L-MT-03-025  
Section 50.54(a)

MONTICELLO NUCLEAR PLANT  
DOCKET 50-263  
LICENSE No. DPR-22

**SUBMITTAL OF REVISION 25 OF THE OPERATIONAL QUALITY ASSURANCE  
PLAN (OQAP)**

**Xcel Energy Operational Quality Assurance Plan, Revision 25**

Figure 1  
NMC and Xcel Energy Organizations with Operational Quality Assurance Responsibilities

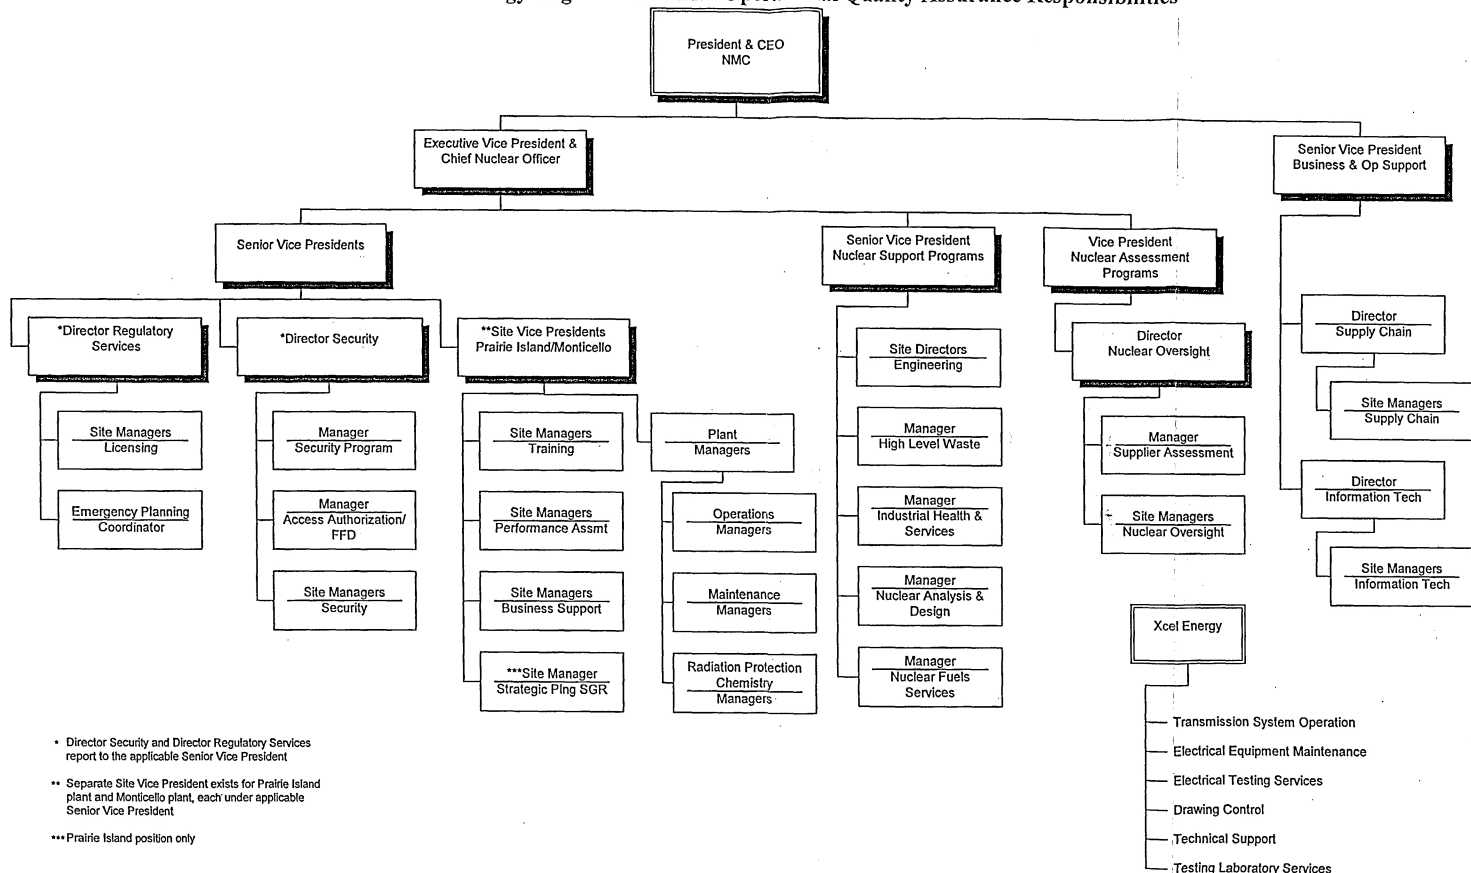
<u>Change Number</u>	<u>Page(s)</u>	<u>Reason (R): Basis (B):</u>
1	-i-	R: Revision number updated to 25. B: Not required; editorial item.
2	9	R: Figure 1 reformatted to reflect the current organization with QA responsibilities. B: As there are title changes, and responsibility reassignment changes only, it does not reduce previous commitments.
